## Columbia County Building Permit

From: The Columbia County Building & Zoning Department  
Plan Review  
135 NE Hernando Av.  
P.O. Box 1529  
Lake City Florida 32056-1529

On the date of January 18, 2007 application 0701-67 and plans for construction of a group A3, Assembly structure uses intended for worship, was reviewed and the following information or alteration to the plans will be required to continue processing this application. If you should have any question please contact the above address, or contact phone number (386) 758-1163 or fax any information to (386) 754-7088.

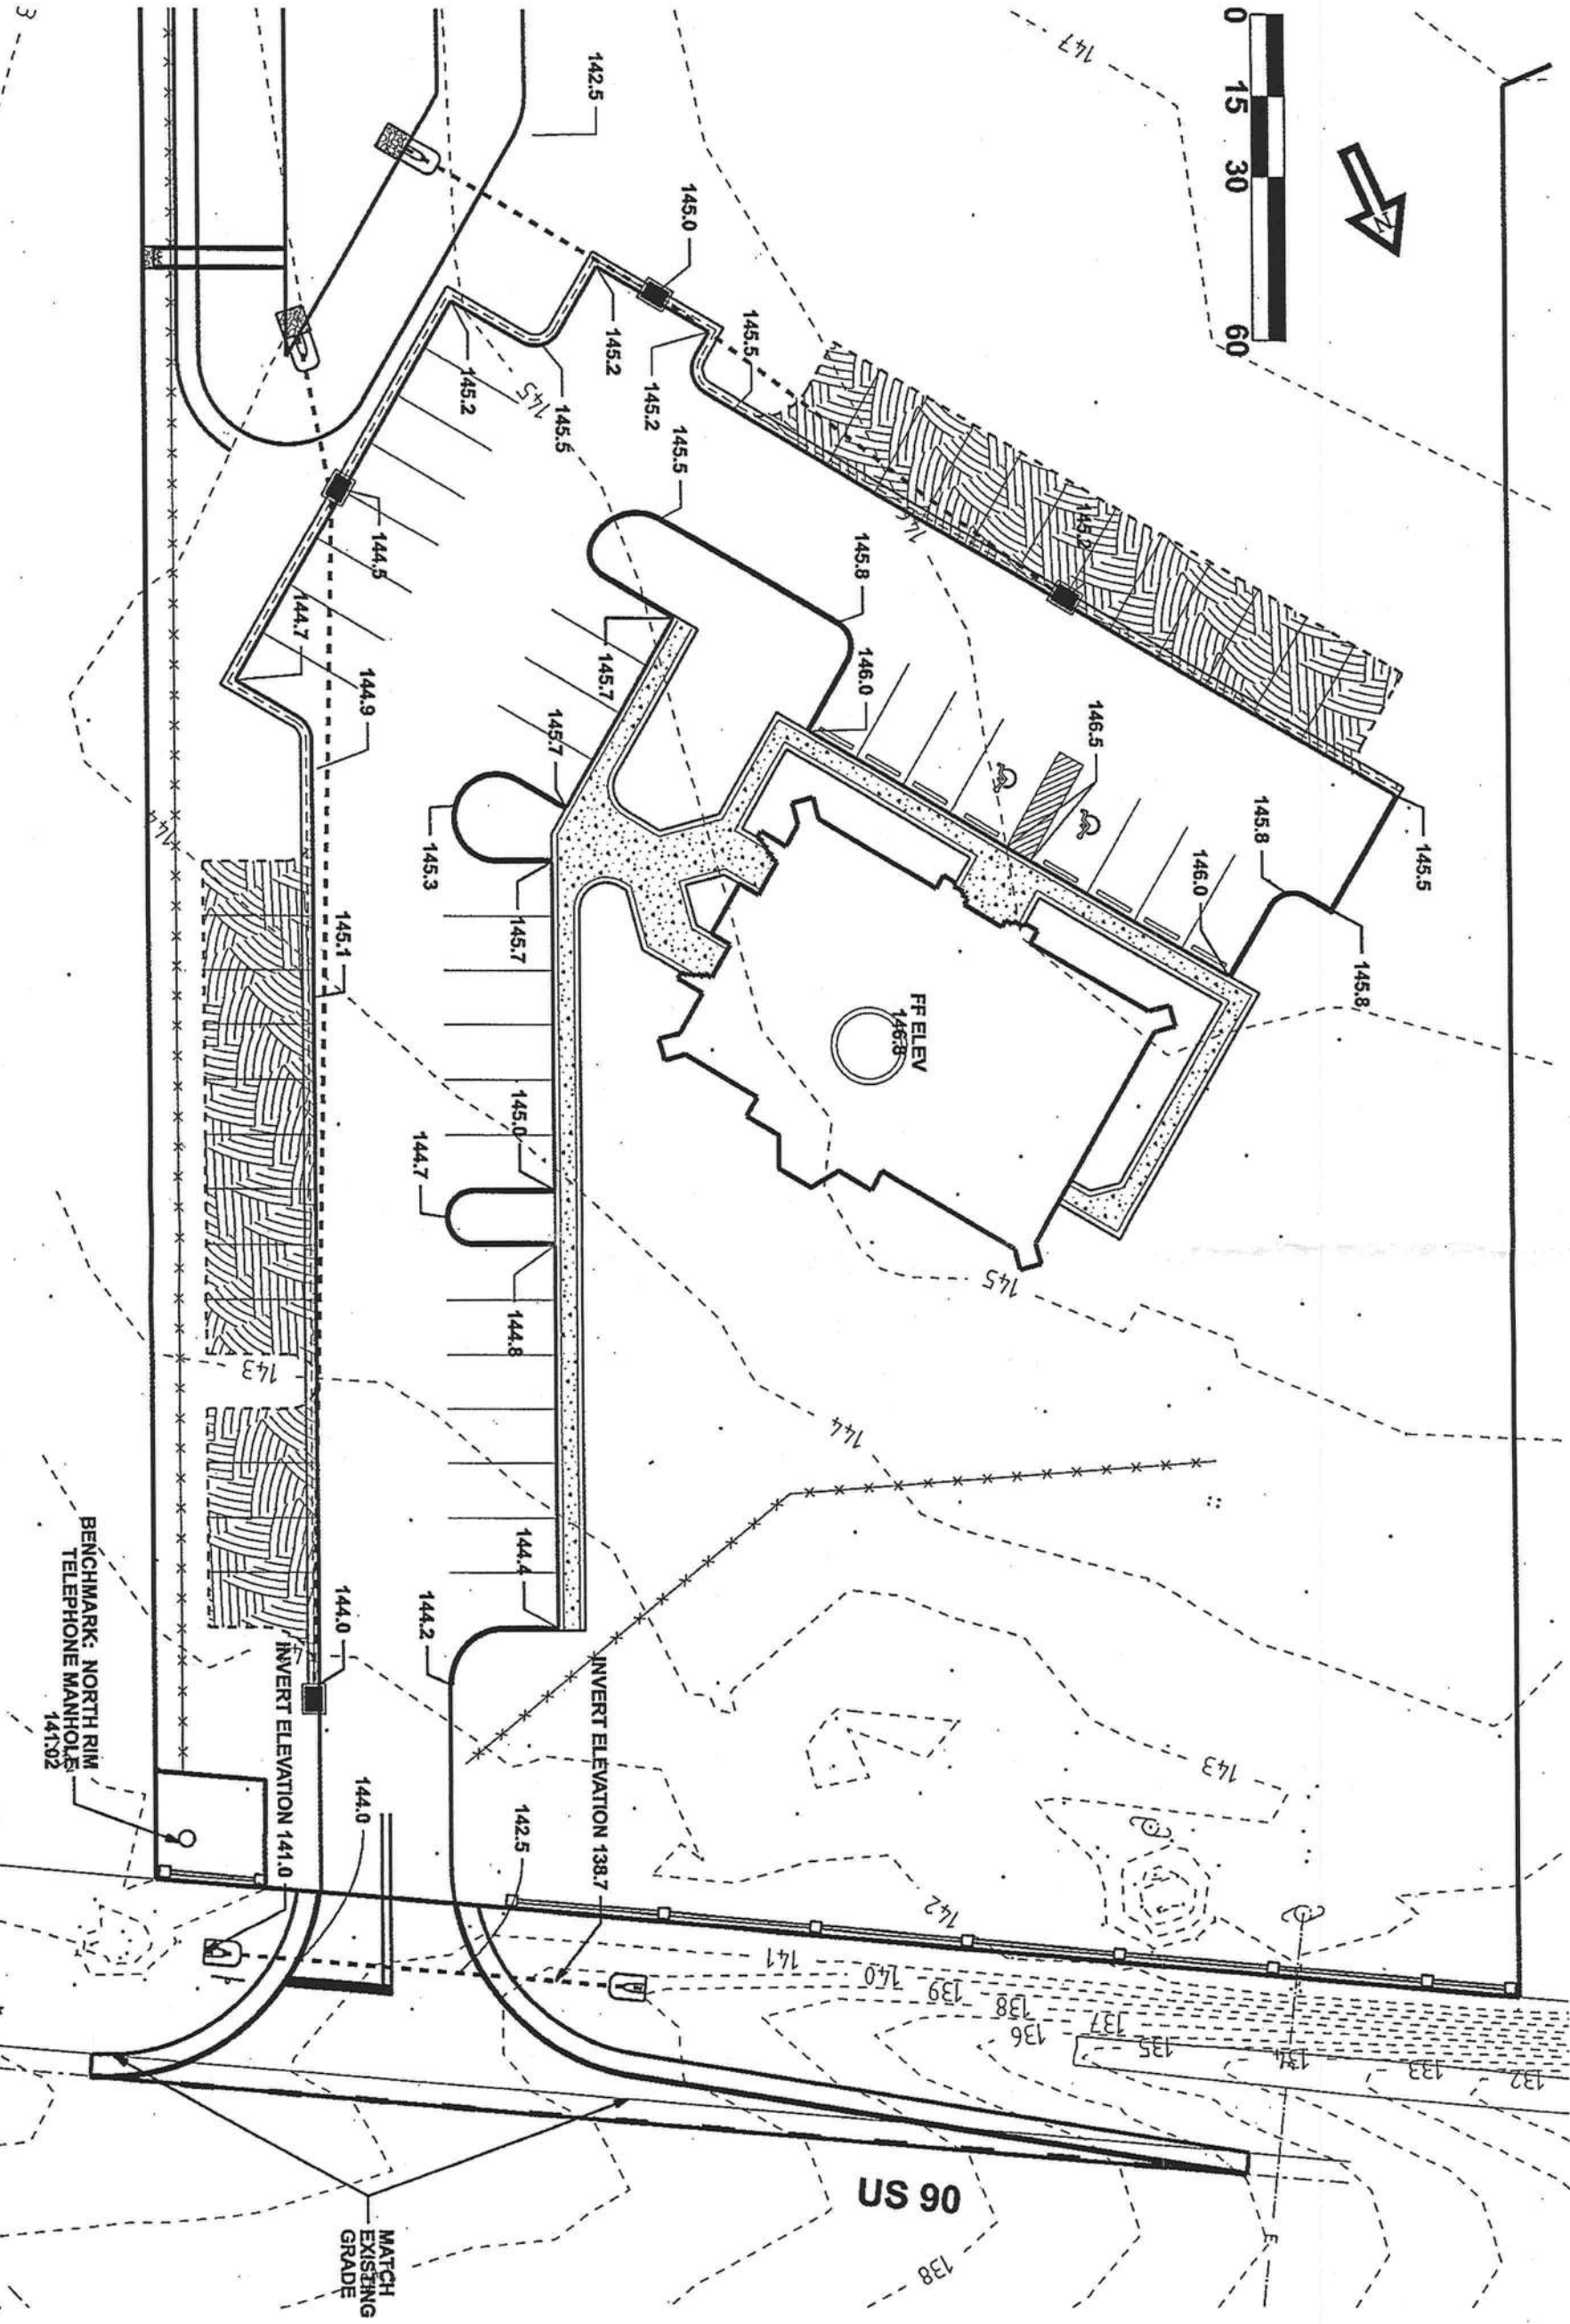
1. Sheet 3 of GTC project # PF05-330 show an access driveway to the property parking lot from US Highway 90 west. Please provide an approval permit for a driveway entry to this property from the Florida Department of Transportation (Mr. Neal Miles)
